V2500-A1/A5/D5 SERIES PROPULSION SYSTEM SERVICE BULLETIN

This document transmits the Initial Issue of Service Bulletin V2500-ENG-72-0633.

ENGINE – ACTUATING MECHANISM HIGH PRESSURE (HP) COMPRESSOR VARIABLE VANES – CONTROL
ROD LOCK NUT TORQUE INCREASE

V2500-ENG-72-0633

Variable Stator Vane (VSV) Actuator Control Rod
Figure 1

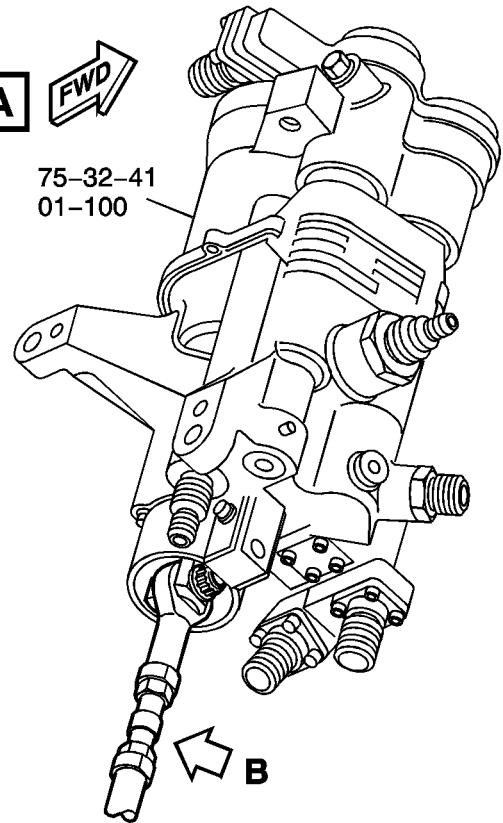
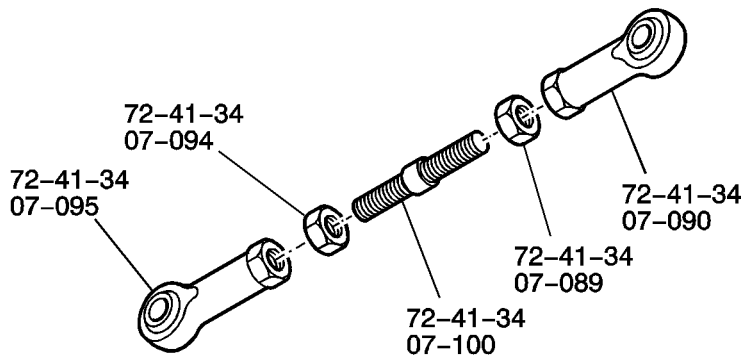
The Locking torque for the Lock nuts on the Variable Stator Vane (VSV) control rod between the VSV actuator and the VSV crankshaft is too low.

Service experience has shown that the instructed locking torque is too low and in several cases has allowed the control rod end connected to the VSV actuator to loosen and rotate.

The attaching bolt on the rotated rod end can cause chafing on the VSV actuator High Pressure (HP) servo fuel supply tube.

This Service Bulletin instructs an increase in the cold build locking torque to prevent loosening of the locknuts.

- (i) Tighten and torque the locknuts (72-41-34, 07-089) and (72-41-34, 07-094) on the VSV actuator control rod to 205 to 220 lbf in. (23 to 25 Nm).
- (ii) Safety the locknuts (72-41-34, 07-089) and (72-41-34, 07-094) to the control rod bearings (72-41-34, 07-090) and (72-41-34, 07-095) with corrosion resistant steel lockwire (Material No. V02-126) (Ref TASK 70-40-11-911-014).

- (i) Tighten and torque the locknuts (72-41-34, 07-089) and (72-41-34, 07-094) on the VSV actuator control rod to 205 to 220 lbf in. (23 to 25 Nm).
- (ii) Safety the locknuts (72-41-34, 07-089) and (72-41-34, 07-094) to the control rod bearings (72-41-34, 07-090) and (72-41-34, 07-095) with corrosion resistant steel lockwire (Material No. V02-126) (Ref TASK 70-40-11-911-803).
